APPLICATION NO.	FILING DATE	FIRST NAMED INVENTOR	ATTORNEY DOCKET NO.	CONFIRMATION NO.
10/810,452	03/26/2004	Sehat Sutardja	MP0467	8949
26703	7590	08/10/2005	EXAMINER	
HARNESSE, DICKEY & PIERCE P.L.C.			VU, BAO Q	
5445 CORPORATE DRIVE			ART UNIT	
SUITE 400			PAPER NUMBER	
TROY, MI 48098			2838

Office Action Summary	Application No.	Applicant(s)	
	10/810,452	SUTARDJA, SEHAT	
	Examiner	Art Unit	
	Bao Q. Vu	2838

DETAILED ACTION

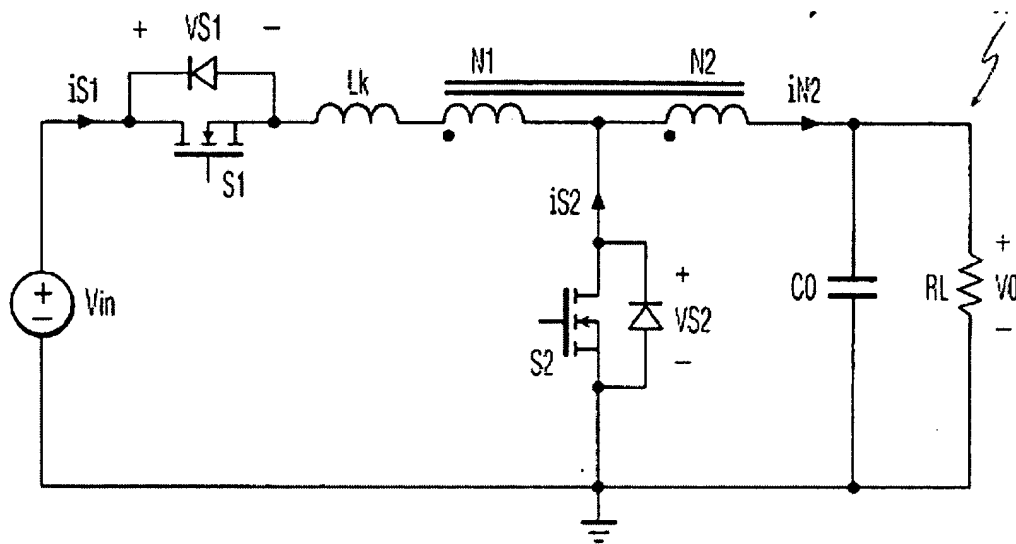
3. Claims 1, 2, 5, 6, 9, 11, 12, 15, 16, 19, 21 and 23 rejected under 35 U.S.C. 102(b) as being clearly anticipated by Qian (USP 6,512,352). Qian discloses the claimed invention a coupled inductor with first, N1, and second, N2, windings connected in series to form a common node, a conduction switch, S1, and a freewheeling switch, S2, the inductor is formed on a single core, and an output capacitor, Co. See figure below.
